# UNITED STATES PATENT AND TRADEMARK OFFICE

APPLICATION NO.	FILING DATE	FIRST NAMED INVENTOR	ATTORNEY DOCKET NO.	CONFIRMATION NO.
10/065,495	10/24/2002	Ronald Scott Bunker	839-1333	9074

**Office Action Summary**

## **DETAILED ACTION**

***Fig. 3 (Prior Art)***

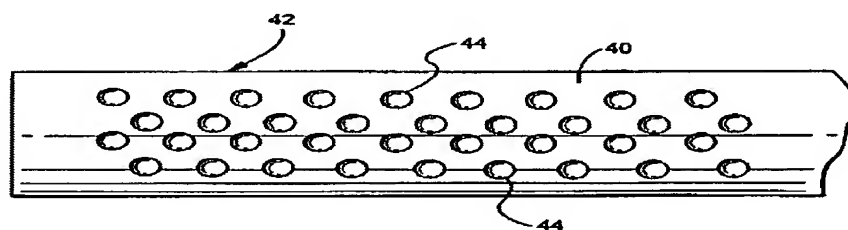
6. Claims 1-3 and 8 are rejected under 35 U.S.C. 102(b) as being anticipated by **Prior Art**

With respect to claim 1, prior art **Figure 3** shows a combustor liner for a gas turbine, the combustor liner having a substantially cylindrical shape; and a plurality of axially spaced

circumferential grooves 44 formed in an outside surface of said combustor liner. See prior art Figure 3 above.

With respect to claim 2, prior art **Figure 3** shows that said grooves 44 are substantially semi- circular in cross-section. See prior art Figure 3 above.

With respect to claim 3, prior art **Figure 3** shows that said grooves 44 are arranged transversely to a direction of cooling air flow. See prior art Figure 3 above.

With respect to claim 8, prior art **Figure 3** shows that said grooves are 44 angled relative to a direction of cooling air (about 90 degrees angle). See prior art Figure 3 above.

**FIG. 5.**

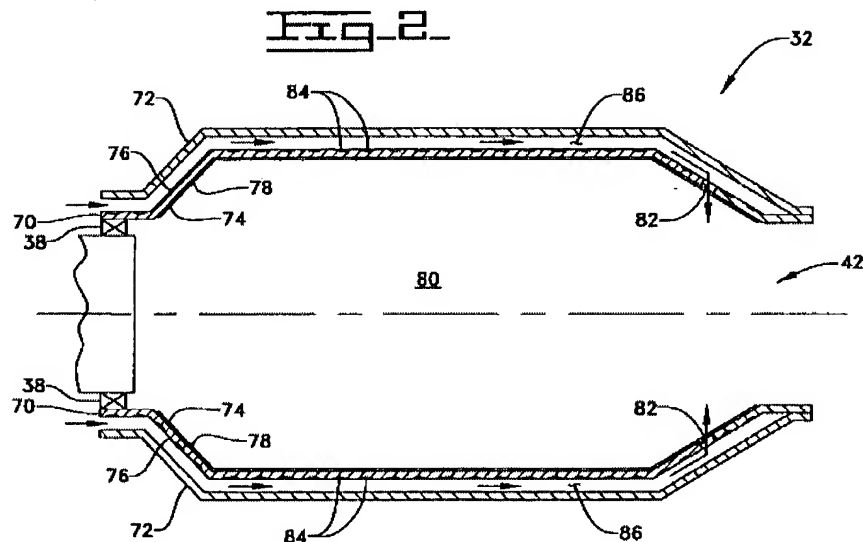
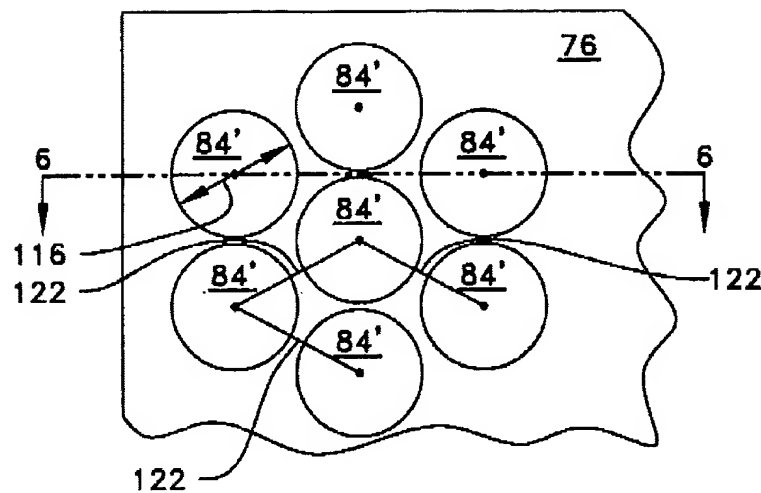
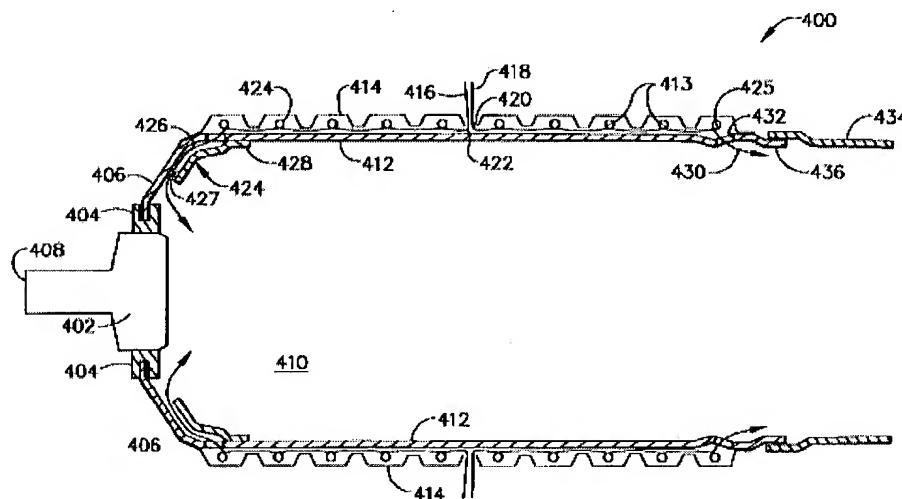
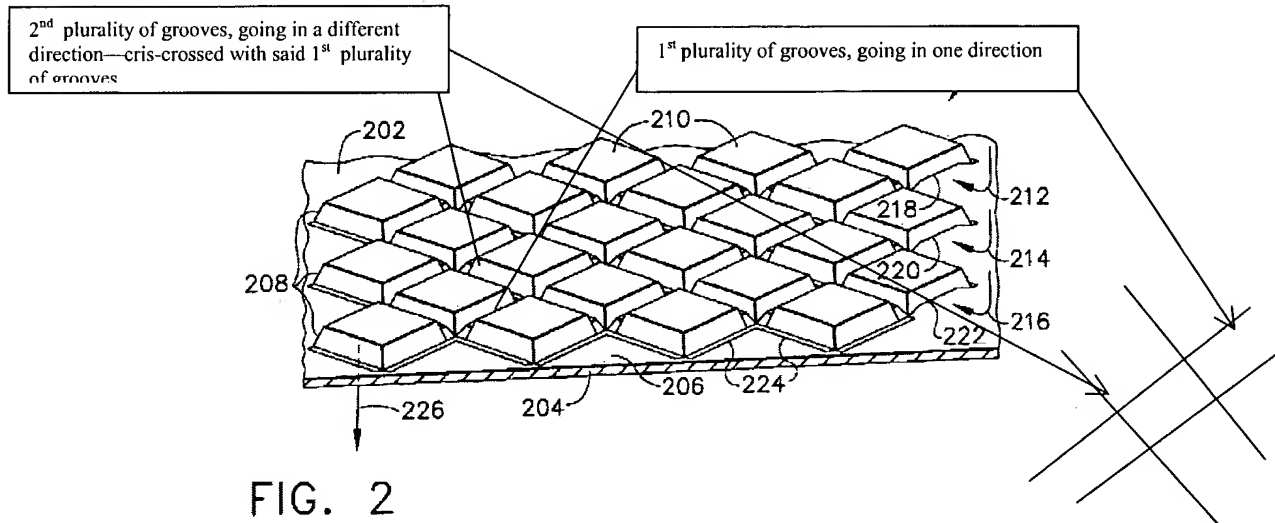
7. Claims 1-3 and 8 are rejected under 35 U.S.C. 102(b) as being anticipated by **Glezer et al.** (U.S. 6,098,397).

With respect to claim 1, **Glezer et al.** teach a combustor liner 70 for a gas turbine, the combustor liner having a substantially cylindrical shape; and a plurality of axially spaced circumferential grooves 84 formed in an outside surface of said combustor liner. See particularly **Figures 2, 5** of Glezer et al.

With respect to claim 2, **Glezer et al.** teach that said grooves 84 are substantially semi-circular in cross-section. See particularly **Figures 2, 5** of Glezer et al.

With respect to claim 3, **Glezer et al.** teach that said grooves 84 are arranged transversely to a direction of cooling air flow. See particularly **Figures 2, 5** of Glezer et al.

With respect to claim 8, **Glezer et al.** teach that said grooves are 84 angled relative to a direction of cooling air (about 90 degrees angle). See particularly **Figures 2, 5** of Glezer et al.

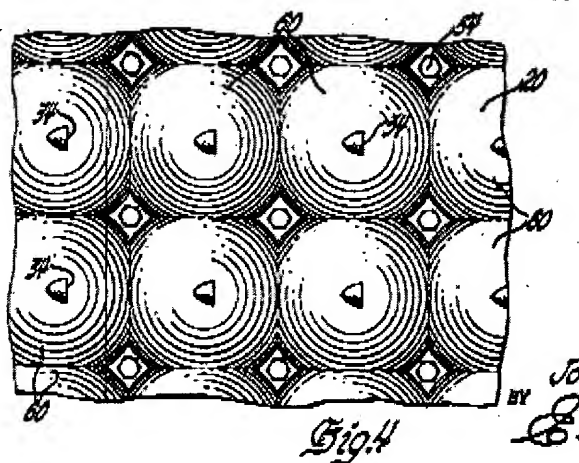
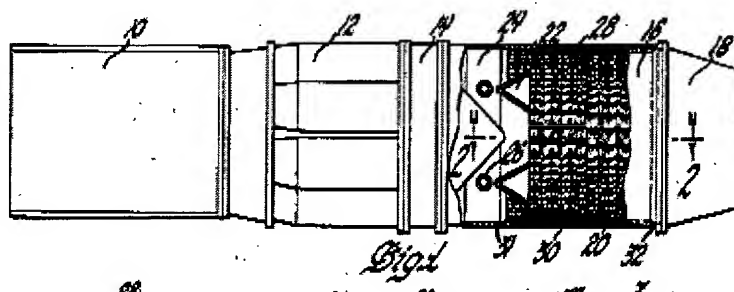
With respect to claims 10, 11, 13, **Glezer et al.** teach a combustor liner 70 for a gas turbine, the combustor liner having a substantially cylindrical shape; and a plurality of axially spaced circumferential grooves 84 formed in an outside surface of said combustor liner, wherein said grooves 84 are substantially semi- circular in cross-section. **Glezer et al.** teaches that said grooves have a diameter, a depth and spacing between adjacent grooves. However, these dimensions do not fall between the ranges claimed in the instant application. Nevertheless, selecting a different diameter, depth and spacing between adjacent grooves is a design choice within the level of one of ordinary skill in the art. This selection could have been based on design constraints such as but no limited to: combustor weight (removal of more material, a lighter combustor), quantity of turbulence required to enhance or increase cooling, etc. Therefore, it would have been obvious to one of ordinary skill in the art at the time the invention was made to have selected different dimensions for the diameter, depth and spacing of Glezer's grooves in order to satisfy certain specific design constraints. See particularly column 4 line 45 to column 5 line 14 of Glezer et al.

With respect to claim 12, **Glezer et al.** teach that said grooves 84 are substantially semi-circular in cross-section. See particularly **Figures 2, 5** of Glezer et al.

With respect to claim 14, **Glezer et al.** teach that said grooves 84 are arranged transversely to a direction of cooling air flow. See particularly **Figures 2, 5** of Glezer et al.

With respect to claim 15, **Glezer et al.** teach that said grooves are 84 angled relative to a direction of cooling air (about 90 degrees angle). See particularly **Figures 2, 5** of Glezer et al.
